RECEIPT DATE: 10/28/15 **ONSITE SEWAGE DISPOSAL SYSTEM** P 557432

PROPERTY ADDRESS: 7374 Guilford Road

I have listed the revisions needed for your BAT plan.

**BAT SITE PLAN**  
7374 GUILFORD ROAD

TRENCH/DRAINFIELD DATA		
WIDTH	INLET	BOTTOM
2'	T1/T2: 2.5' T3/T4: 4'	6' 8'
NUMBER OF TRENCHES 4		
TOTAL LENGTH 235'		
ABSORPTION AREA 470' + SIDEWALL		
DISTRIBUTION BOX LEVEL YES 05/11/13		
DISTRIBUTION BOX BAFFLE YES		
DISTRIBUTION BOX PORT YES

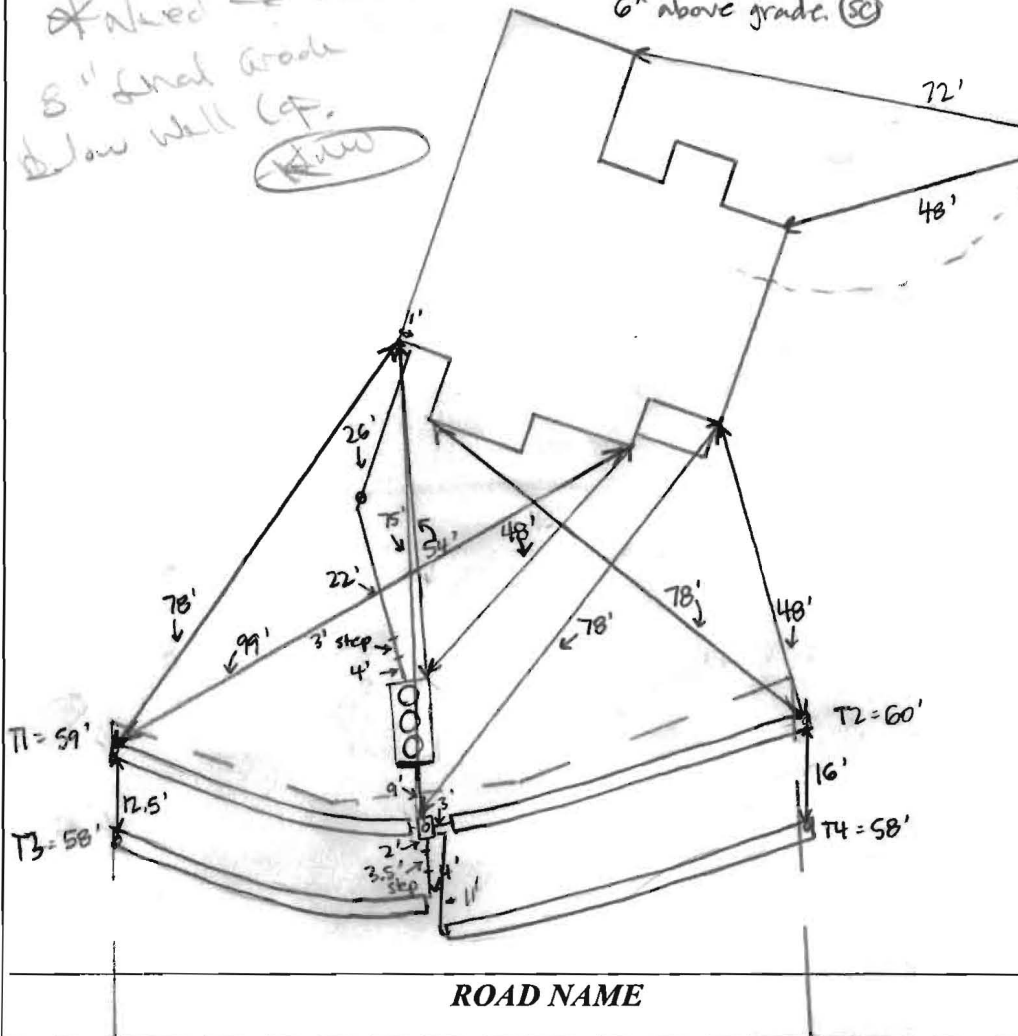
2/16/16 Norweco startup - alarm sounds, aerator runs. Contractor added ricers while on site manholes now 6" above grade. (SC)

\*Need to verify  
 8" final grade  
 below well (cf. new)

11/2/15 One stake of SDA and BAT tank stake missing. Notified Dan with Viking Homes that entire area and tank must be staked before we can proceed with layout. (SC)  
 11/5/15 Met Sams Creek on site for layout. Dan from Viking Homes also on site.  
 All SDA + tank stakes present. Laid out 3 x 57' trenches on contour, 2' wide. (SC)

11/12/15 T1-T3 complete. T1 covered and T2-T3 filled with stone/pipe/cloth + left open. T1 + T2 are not installed per spec - inlet is 2.5' and bottoms 6'. T3 has inlet 4', bottom 8'. Need a 4th trench in order to have enough absorption area - 57' long, inlet 4', bottom 8'. Install 12' below T2 to avoid large tree. SDA will have adequate area for 2 replacement even with bedroom addition. (SC) 11/12/15 T4 dug + left open. 8' depth, soil profile correlates with perc tests. (SC) 11/12/15 Filling T4 with stone - 4' to invert depth. New D-box installed but not connected. Need to level speed levelers. (SC)

FINAL INSPECTOR Sarah Collins DATE OF APPROVAL 2/11/16  
 11/13/15 Last trench installed, planked, must @ 4' bottom of trench not seen.  
 WLE inspected. OK to com system. Need BAT startups for final approval (SC)

**BAT SITE PLAN**  
7374 GUILFORD ROAD

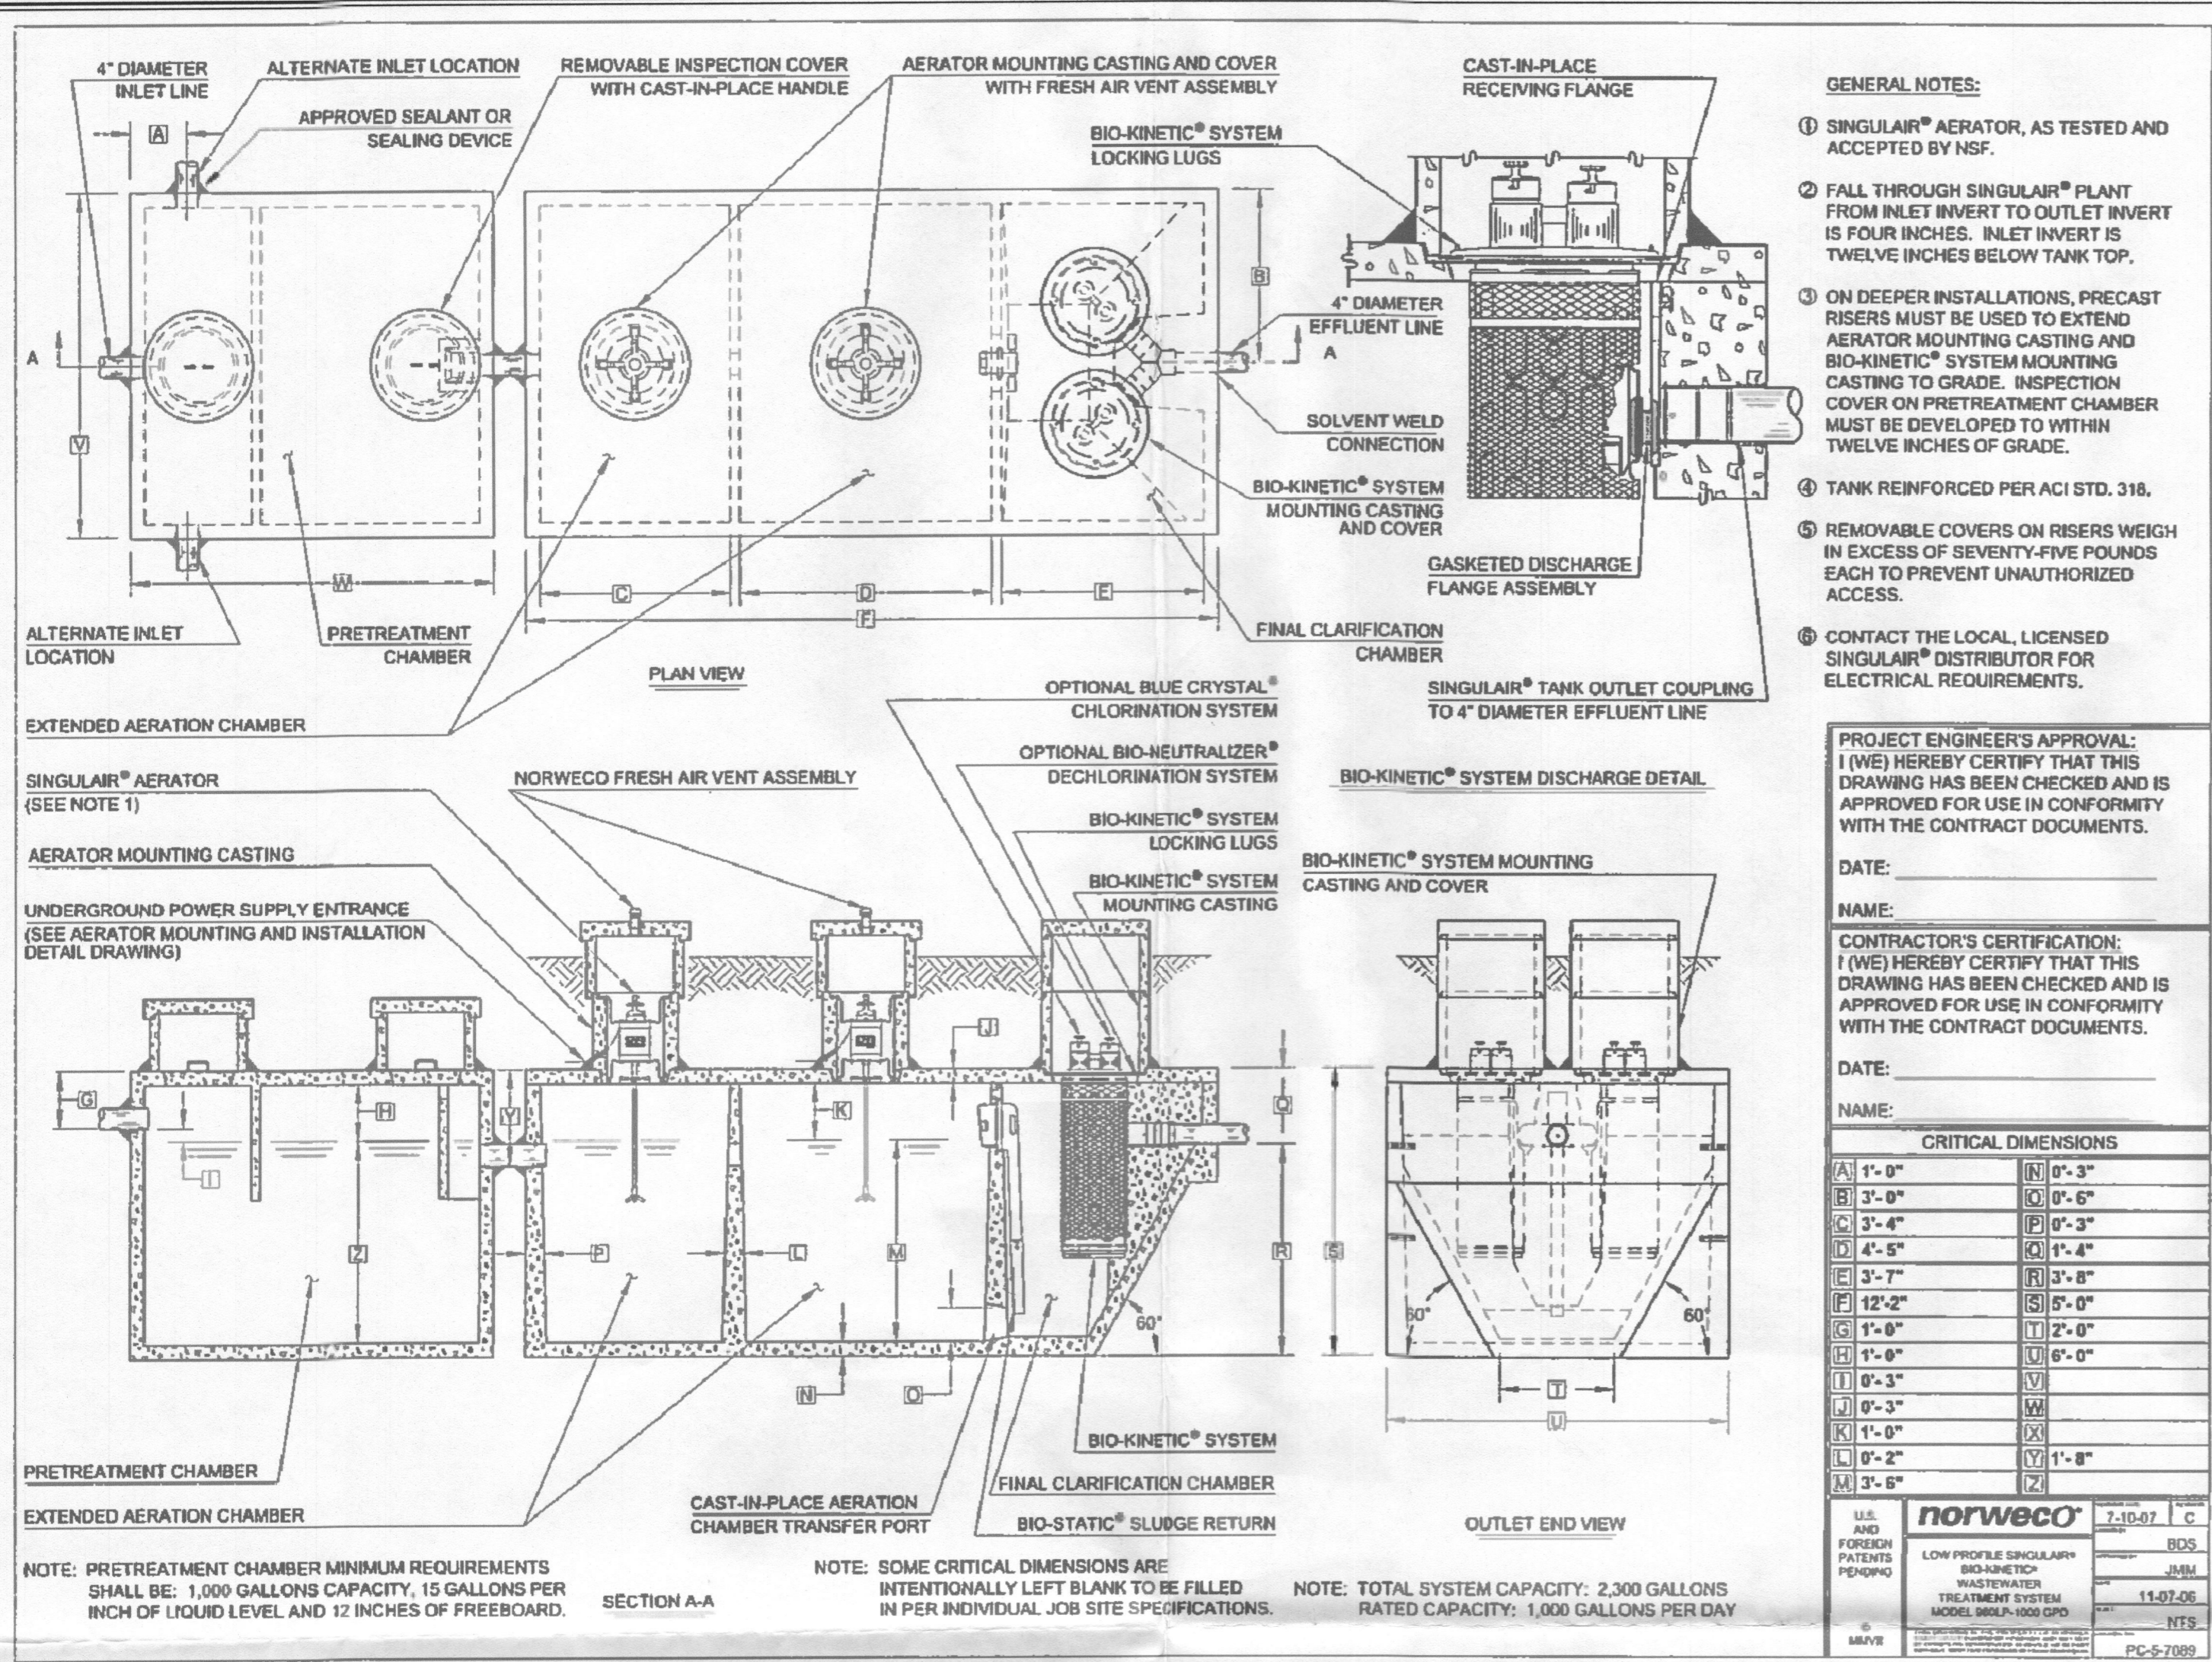
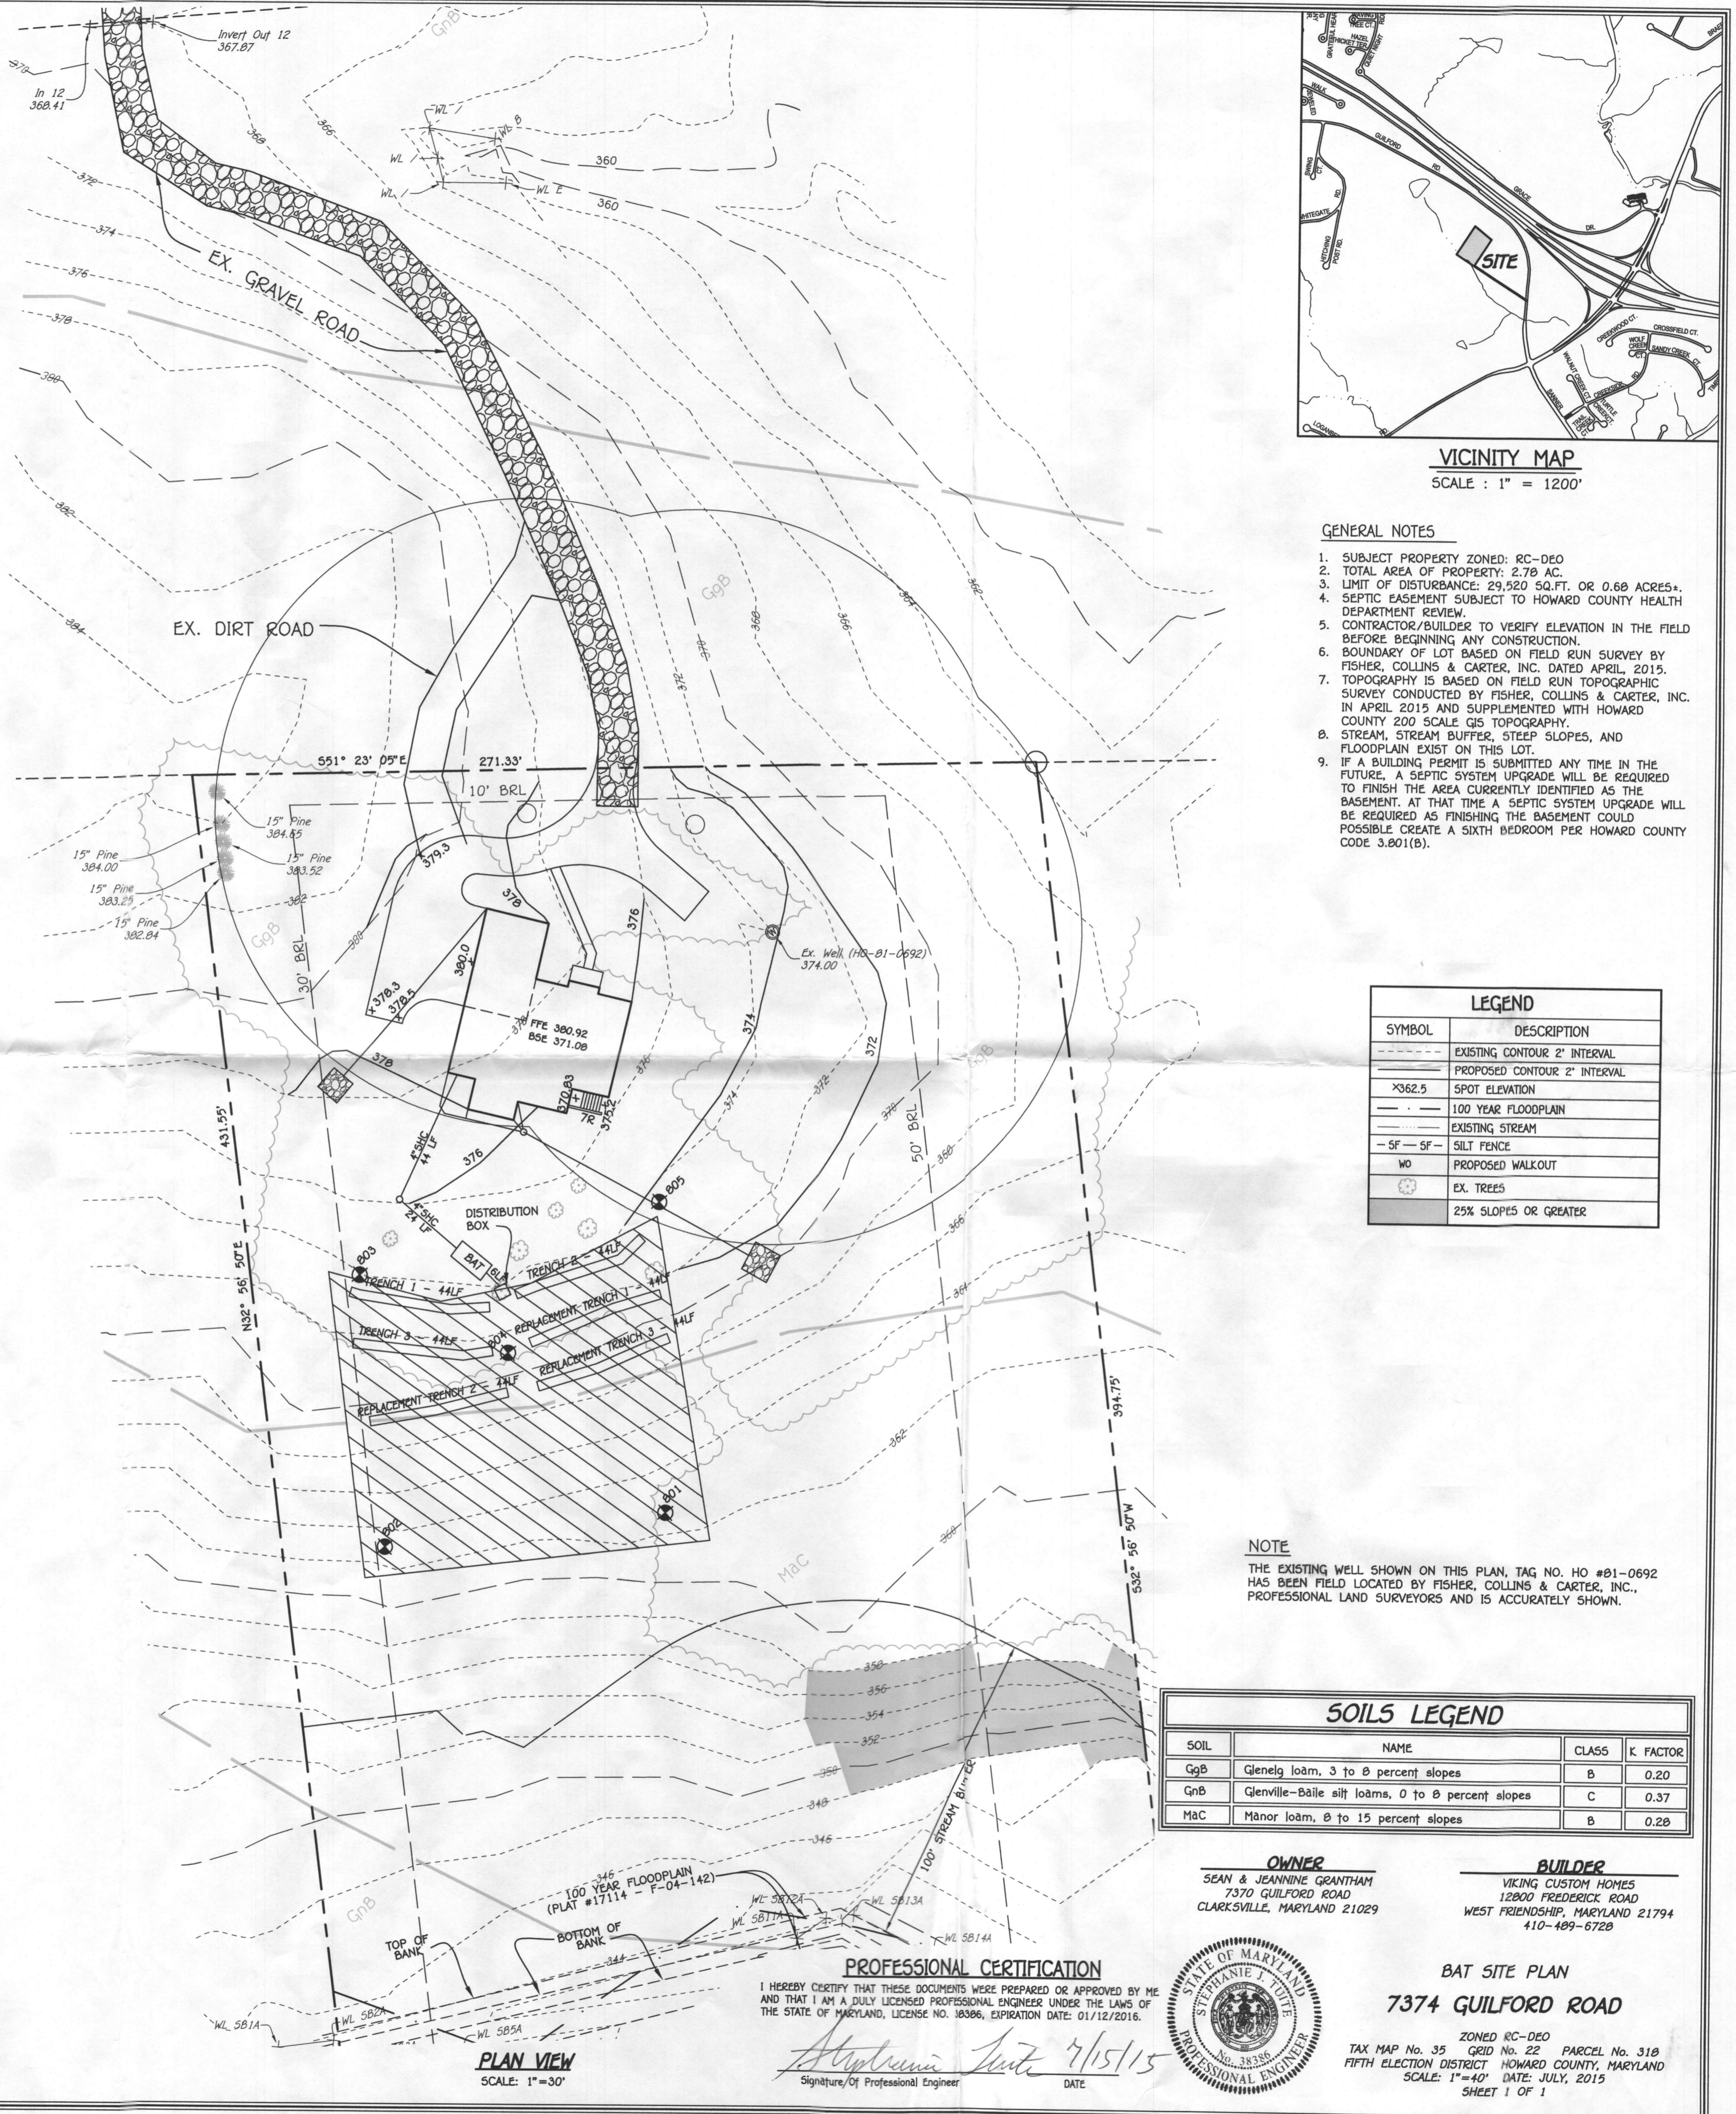
- ❖ We will need to change the number of bedrooms on your building permit to reflect the number of bedrooms shown on your BAT plan.
- ❖ Revise calculations on your BAT plan to reflect proposed number of bedrooms.
- ❖ Remove line 5 from the general notes.
- ❖ Currently your floor plans reflect 5 bedrooms with a possible 6<sup>th</sup> bedroom in the basement I recommend this statement be added to the general notes.

If a building permit is submitted any time in the future, a septic system upgrade will be required to finish the area currently identified as the basement. At that time a septic system upgrade will be required as finishing the basement could possible create a sixth bedroom per Howard County code 3.801(B).
